Access Compliance Report

Public Rights-of-Way

(Curb Ramps)

Intersection ID: 21295	Main Street: PARK_SOUTH_DR	Cross Street: CYPRESS_CLUB_DR	Location: W
ADA ID: 465CFB25358C	Ramp Type: PerpDiag	Initial Pass/Fail: Pass	Overall Compliance: No
		Severity Score: 0.25

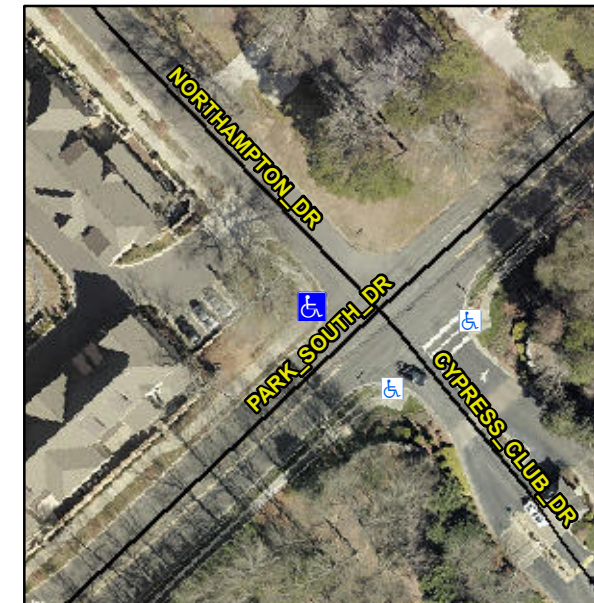
Not Found, R304.5.3, R305.2

Compliance	Description	Data	Compliance	Description	Data
N/A	Ramp Length (in)	32.0	Yes	Ramp Slope (%)	6.3
Yes	Ramp Width (in)	48.0	No	Ramp XSlope (%)	3.2
N/A	Flare Type LT	Sloped	N/A	Flare Type RT	N/A
N/A	Flare Slope LT (%)	0.5	Yes	Flare Slope RT (%)	5.1
N/A	Flare Traversable LT?	Yes	N/A	Flare Traversable RT?	Yes
Yes	Landing Length (in)	67.0	Yes	DWS Provided?	Yes
Yes	Landing Width (in)	48.0	Yes	DWS Contrast?	Yes
Yes	Landing Slope (%)	0.7	Yes	DWS Length (in)	24.0
No	Landing X Slope (%)	3.9	Yes	DWS Full Width?	Yes
N/A	Landing Curb? (Y/N)	No	No	DWS Offset (in)	5.0
N/A	Shared Landing?	No			
Yes	Gutter Ponding?	No	Yes	Gutter Slope (%)	2.6
Yes	Gutter Lip Ht (in)	0.0	No	Gutter X Slope (%)	2.7
N/A	Painted X Walk1?	No	N/A	Painted X Walk2?	No
	X Walk 1 Direction	To SE		X Walk 2 Direction	To NE
N/A	X Walk 1 Width (in)	N/A	N/A	X Walk 2 Width (in)	N/A
	X Walk 1 Slope (%)	8.5		X Walk 2 Slope (%)	5.5
	X Walk 1 X Slope (%)	7.5		X Walk 2 X Slope (%)	0.9

Remove & Replace Curb Ramp With Two New Directional Ramps or Equivalent. Remove & Replace Gutter.
